ADDENDUM NO. 3

SUBJECT: Addendum No. 3 – Magnolia Avenue Streetscape Project

PROJECT NO.: 15A-R-0584 & 16A-R-0609

PROJECT No. 16A-R-0609	YEAR 2017	SHEET No. 2E	
REVISIONS			
No.	DATE	BY	BRIEF DESCRIPTION
1	02-22-2018	MLK	ADDENDUM 3 - CROSSWALK REVISION

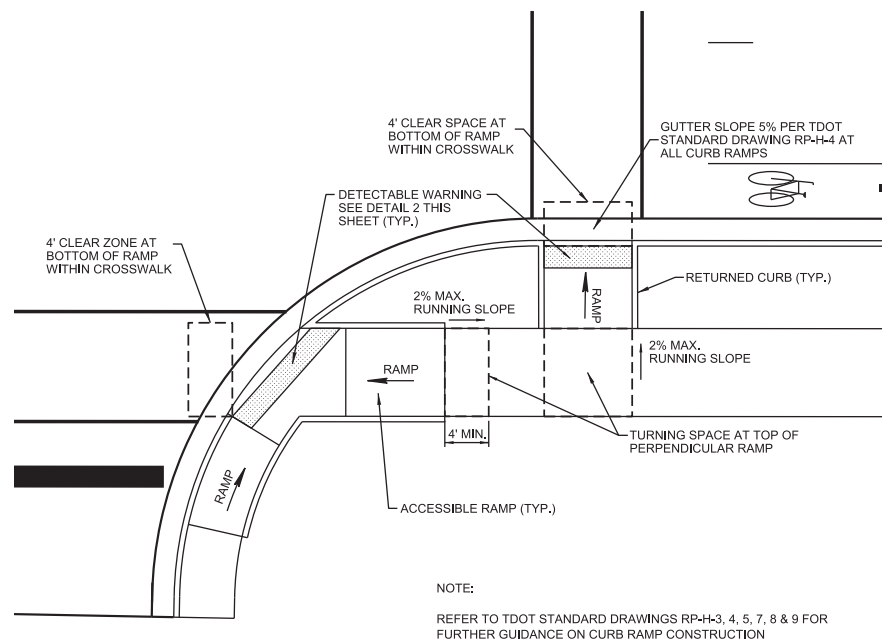
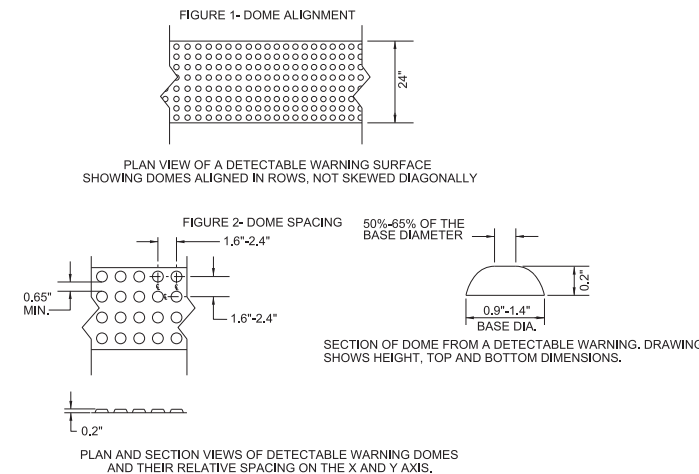
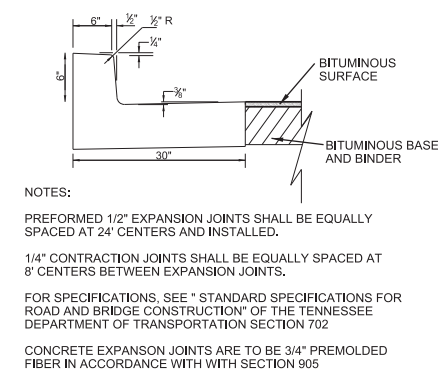
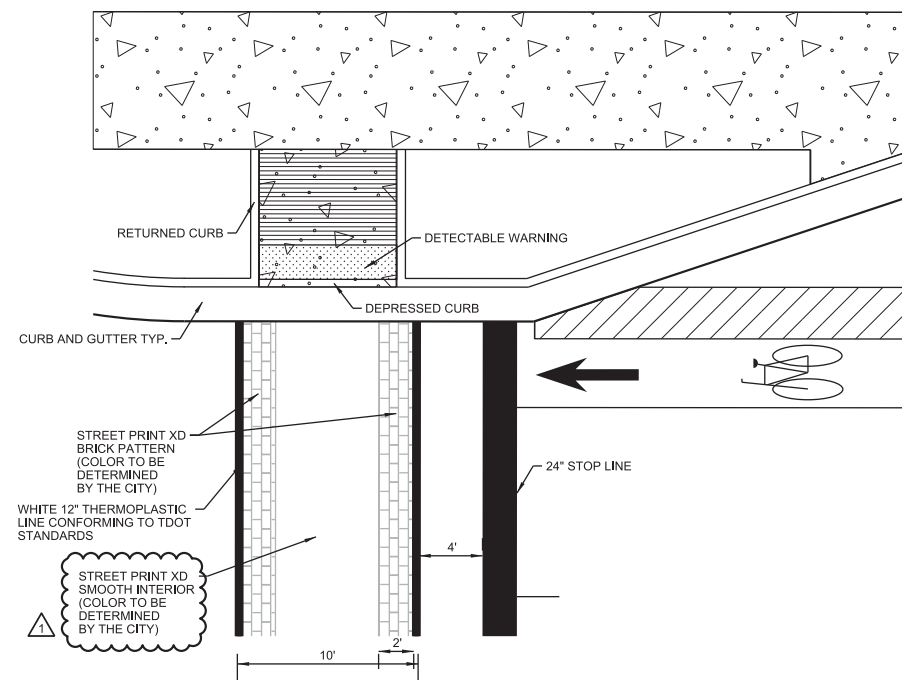
- 9.) Phase II, Sheet 2B – Revised keynote 11
- 10.) Phase II, Sheet 2D – Revised grate elevation for Structure 38A
- 11.) Phase II, Sheet 2E - Street print XD detail added

PROJECT No.	YEAR	SHEET No.	
16A-R-0609	2017	4	
REVISIONS			
No.	DATE	BY	BRIEF DESCRIPTION
1	02-22-2018	MLK	ADDENDUM 3 - DISPLAYED WATER LINE

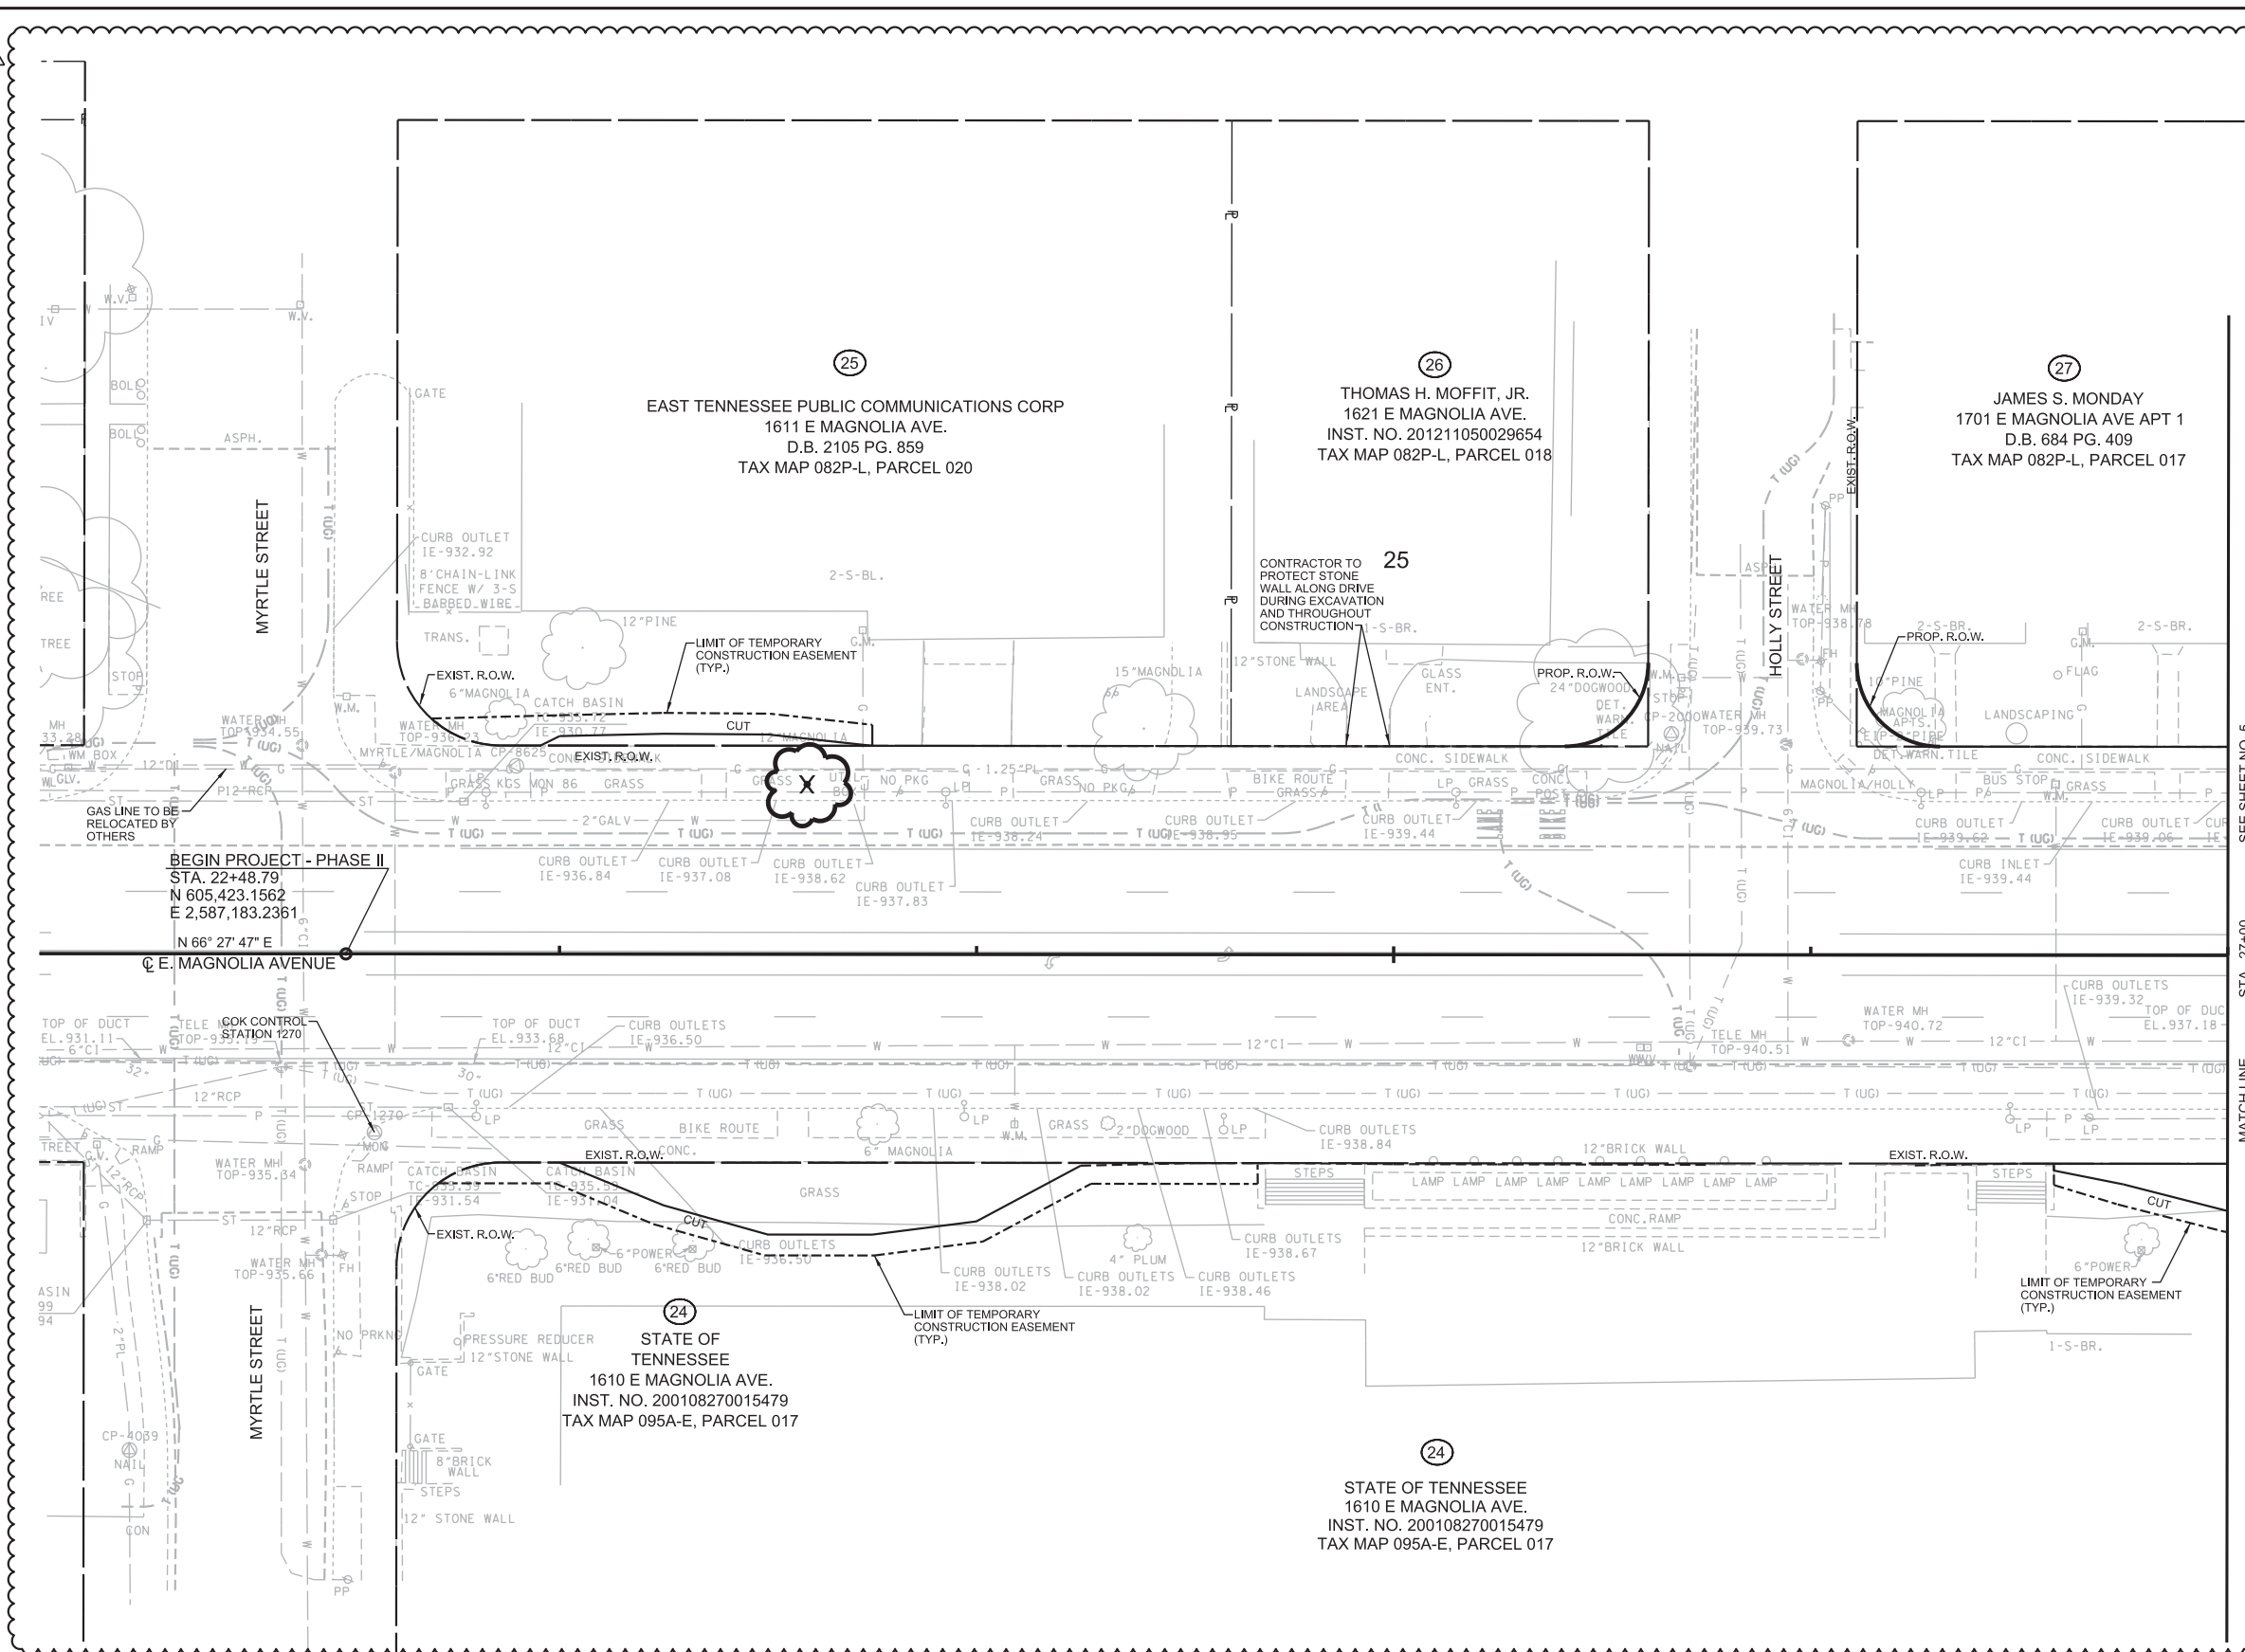
- 12.) Phase II, Sheet 4 – Displayed water linework
- 13.) Phase II, Sheet 5 – Displayed sanitary linework
- 14.) Phase II, Sheet 5A - Removed hatching where drain pipes are to be abandoned

PROJECT No.	YEAR	SHEET No.	
16A-R-0609	2017	6	
REVISIONS			
No.	DATE	BY	BRIEF DESCRIPTION
1	02-22-2018	MLK	ADDENDUM 3 - DISPLAYED SANITARY

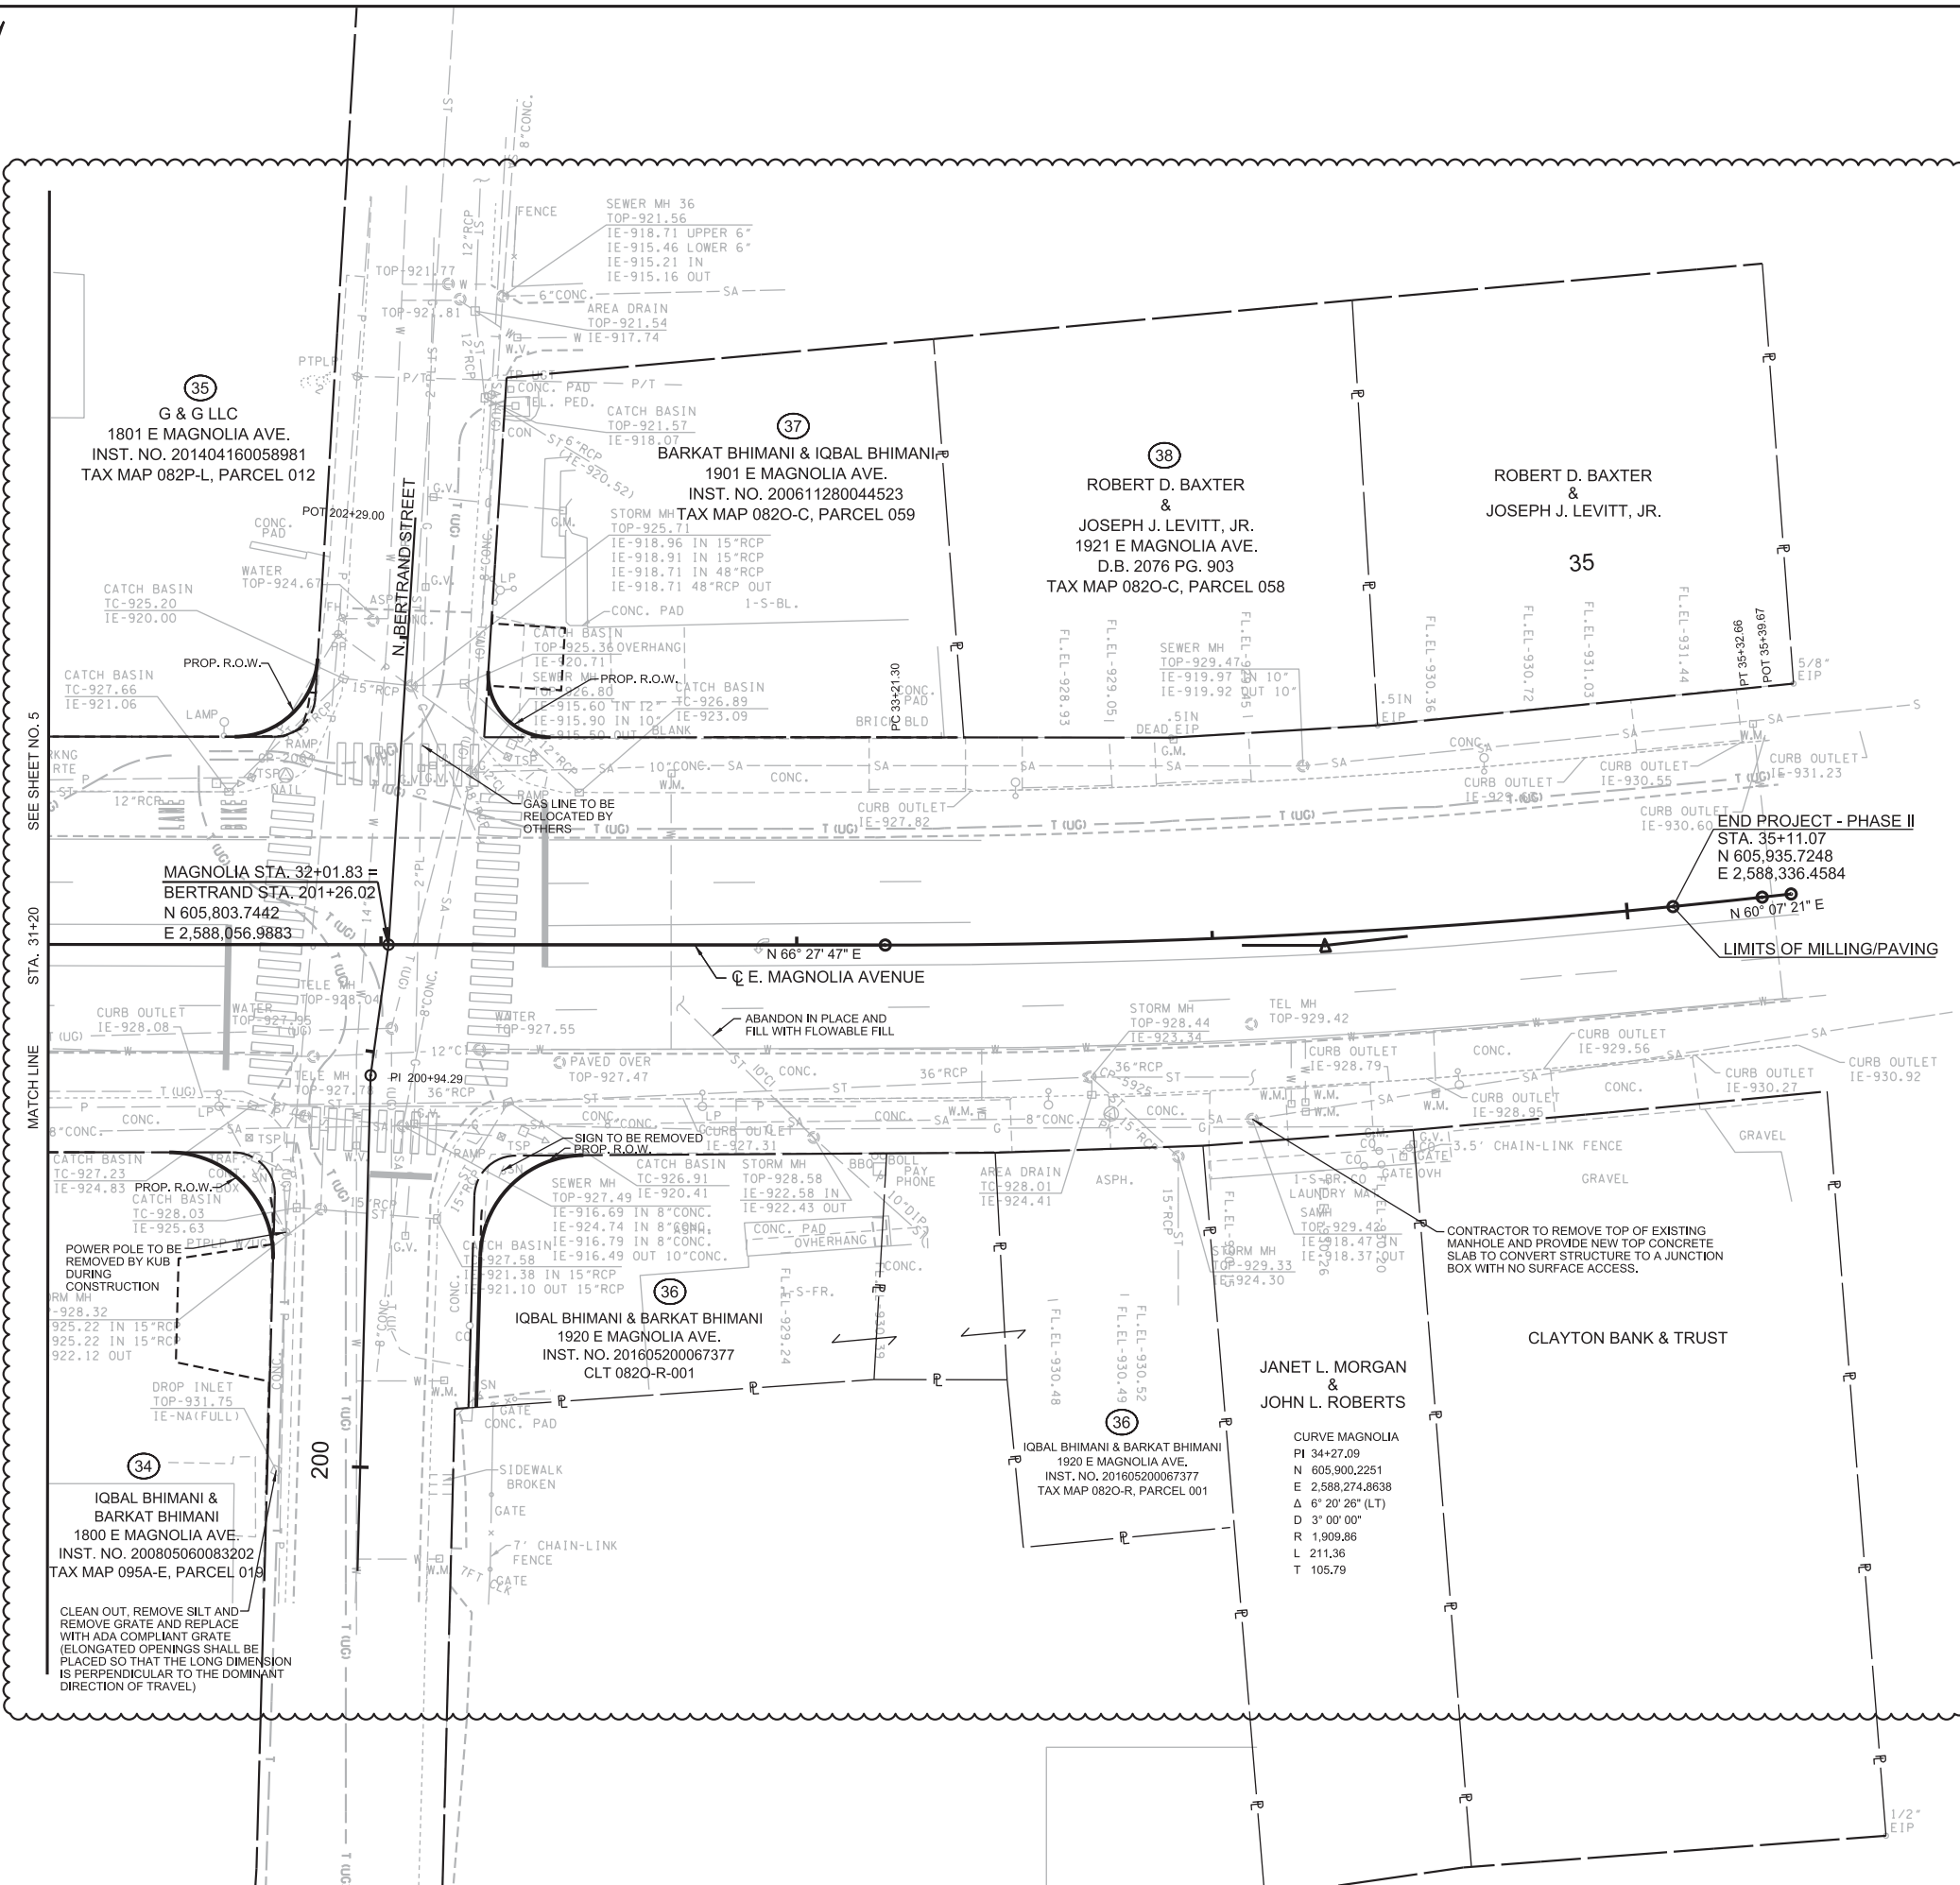
- 15.) Phase II, Sheet 6 – Displayed sanitary linework
- 16.) Phase II, Sheet 27 – Revised cross section at Sta. 33+00
